BID ADDENDUM NO.1

2181539 Bank on Buffalo, Niagara Falls, NY

There was an error during the printing process that caused the structural & HVAC items to not appear in the Architectural drawings. Some of the drawings being replaced are only to show the missing items for clarification. No actual changes are occurring on these sheets. Any changes to the drawings are clouded & tagged.

A311

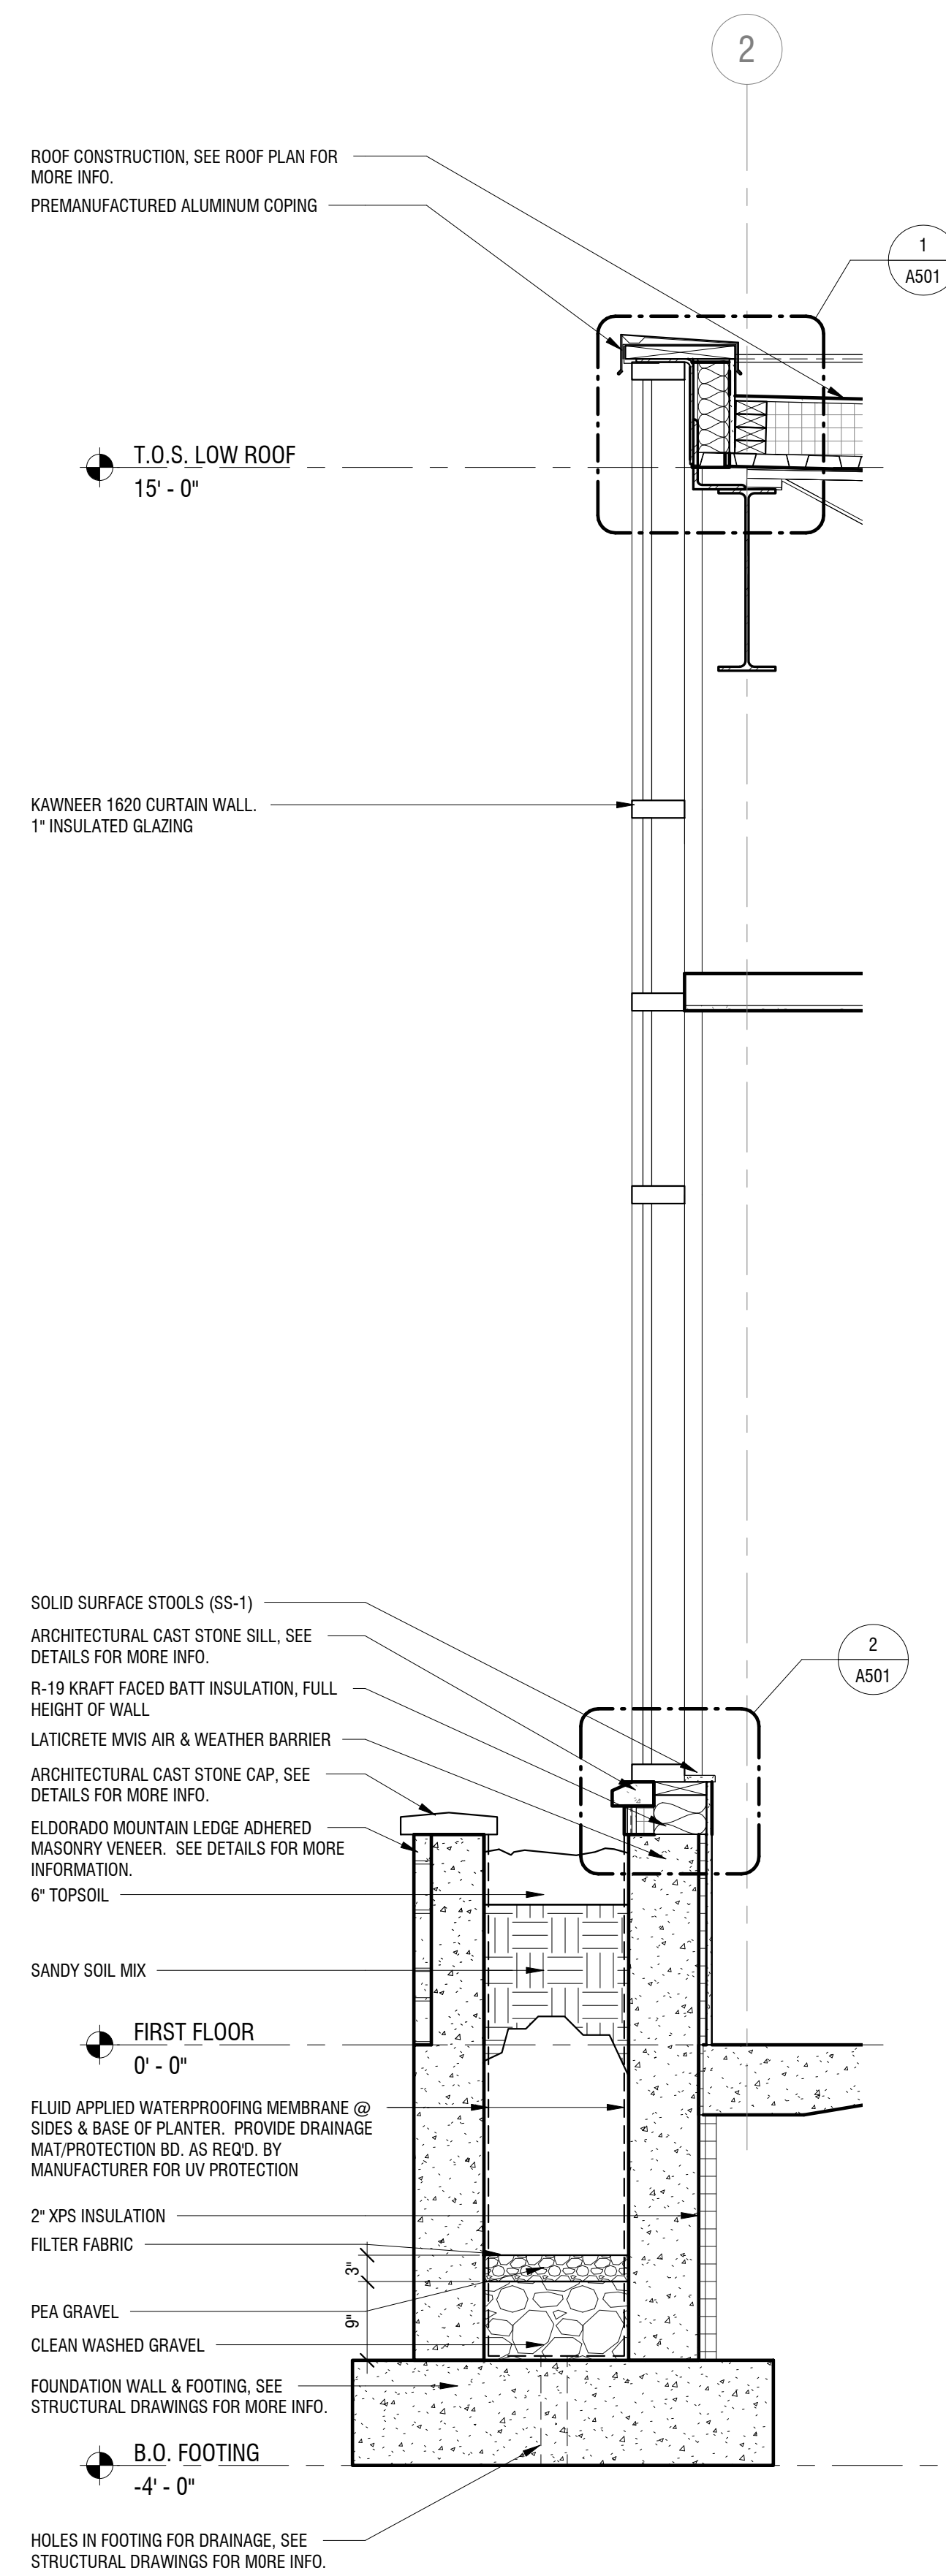
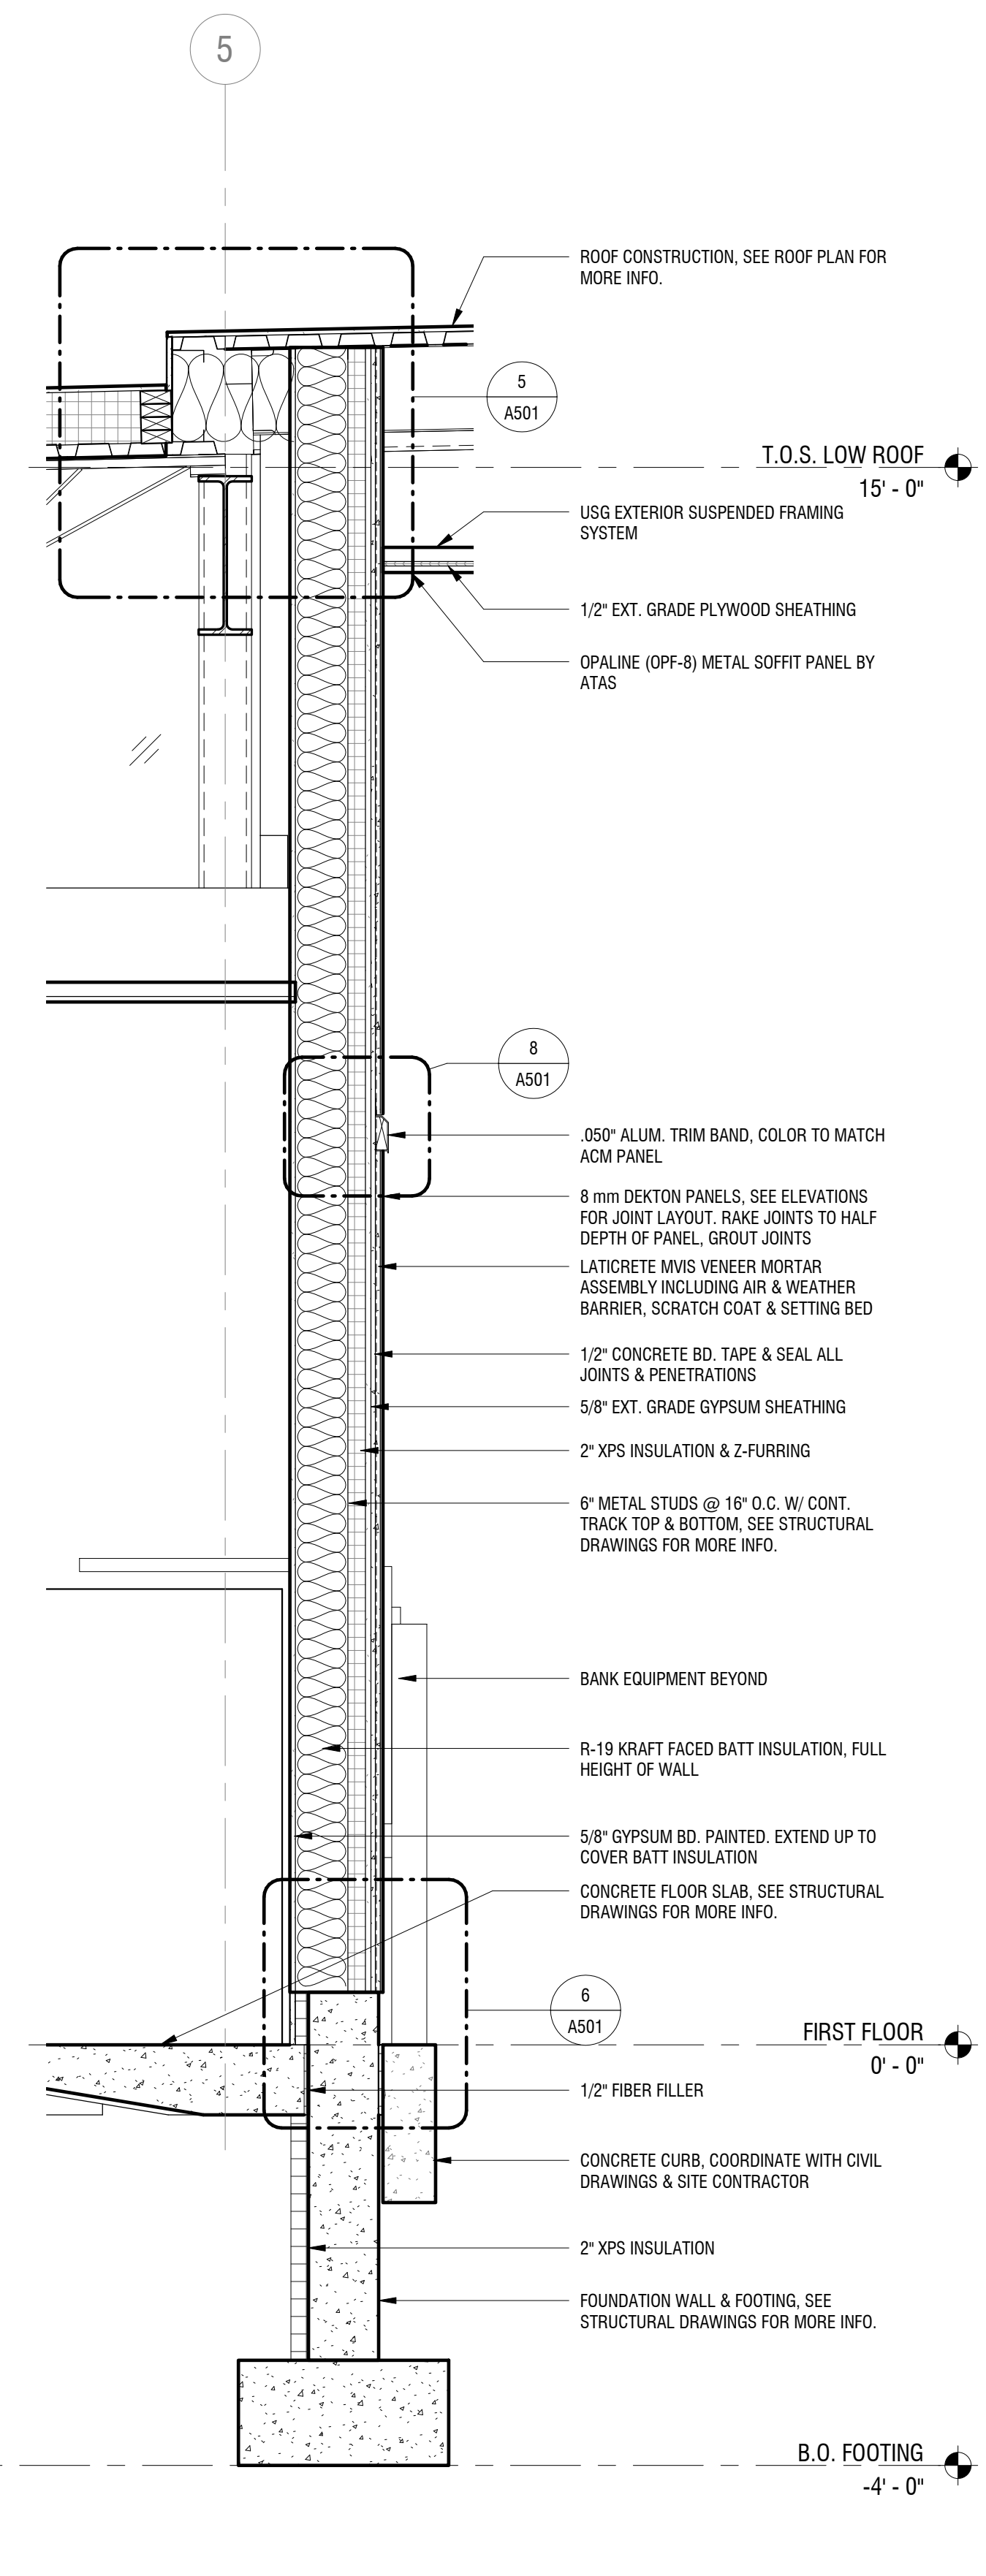
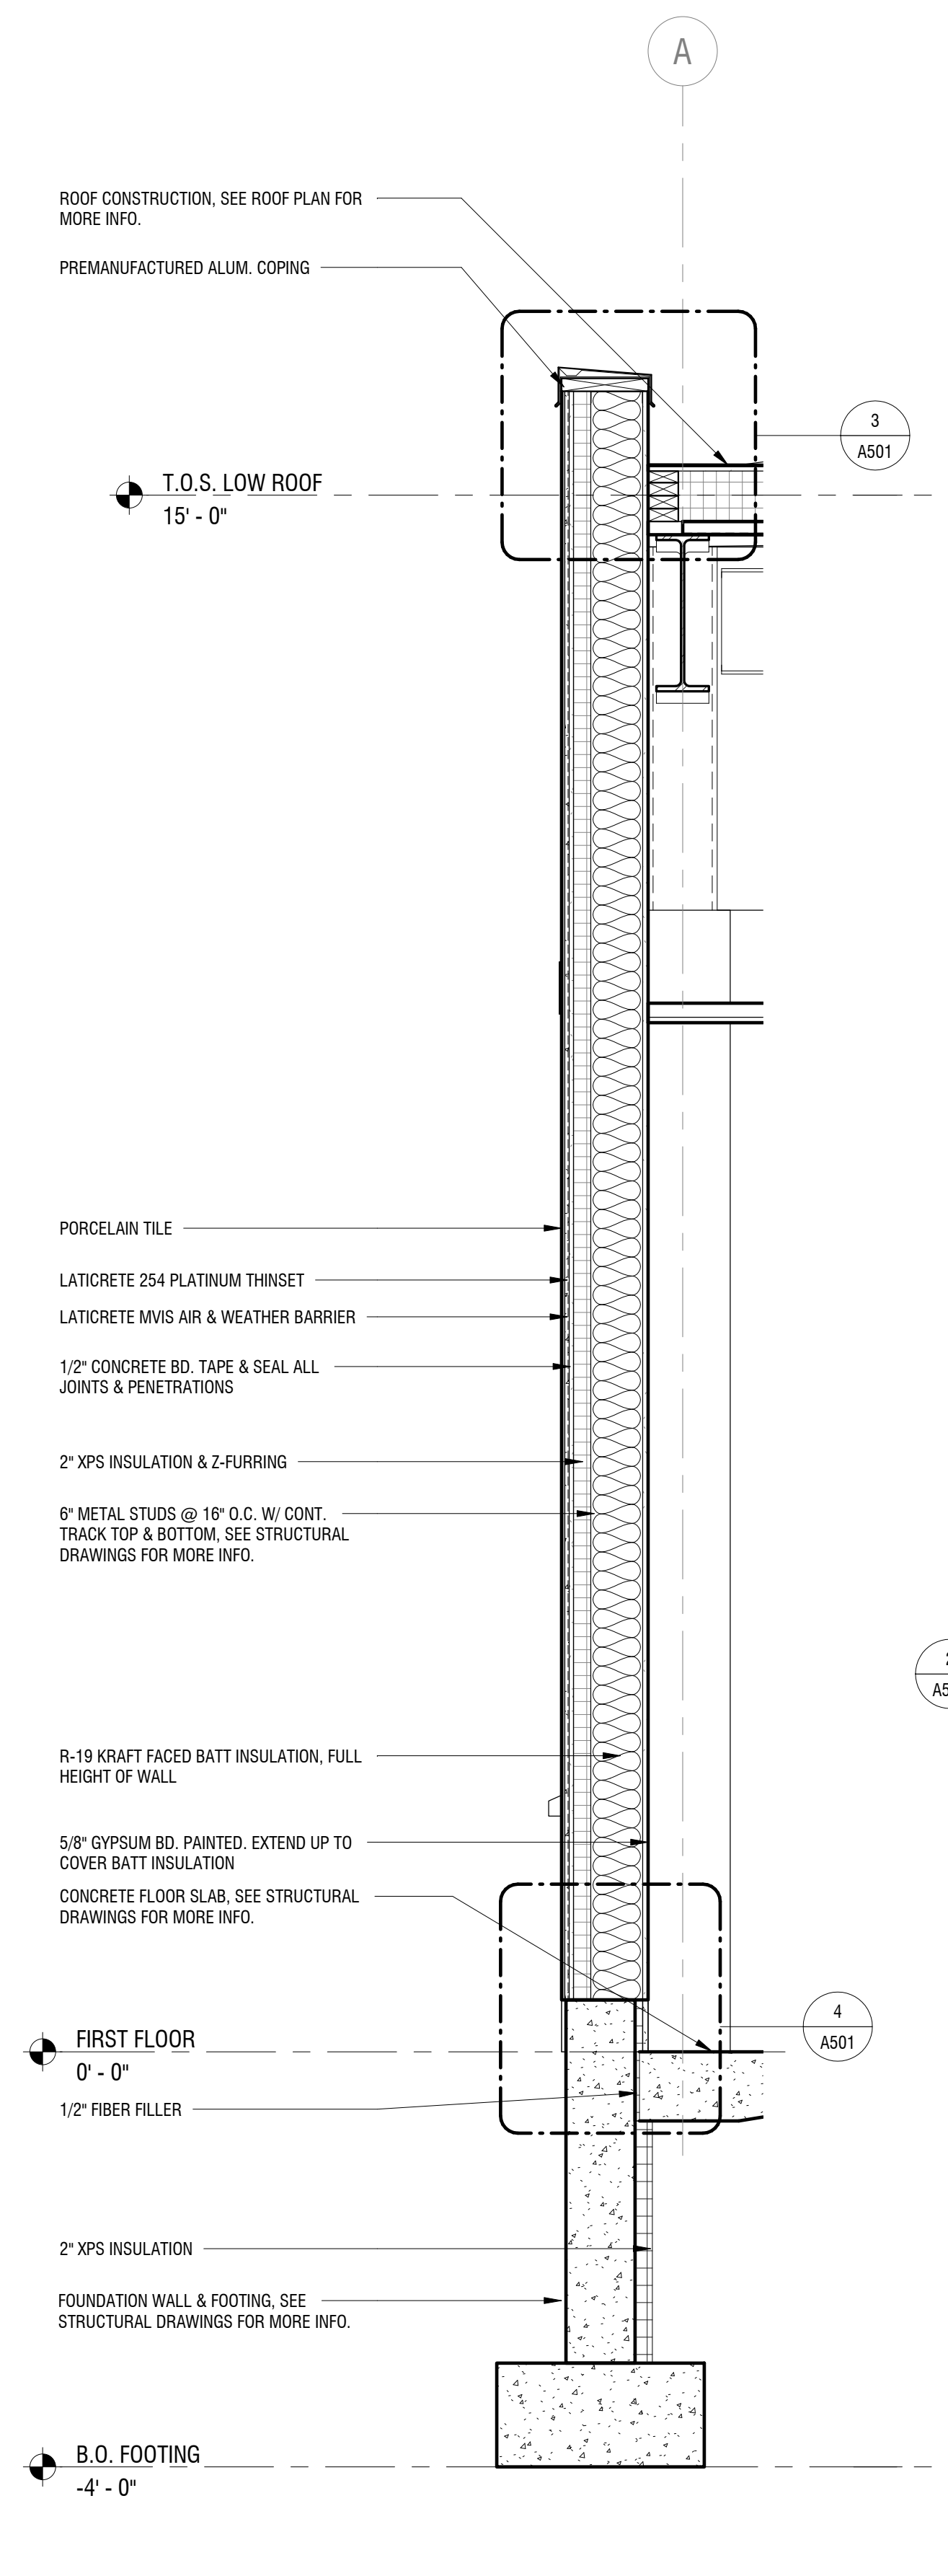
- J. Drawing A311**
 - 1. DELETE Drawing in its entirety
 - 2. ADD replacement Drawing A311
 - 3. HVAC & structural shown on drawings.
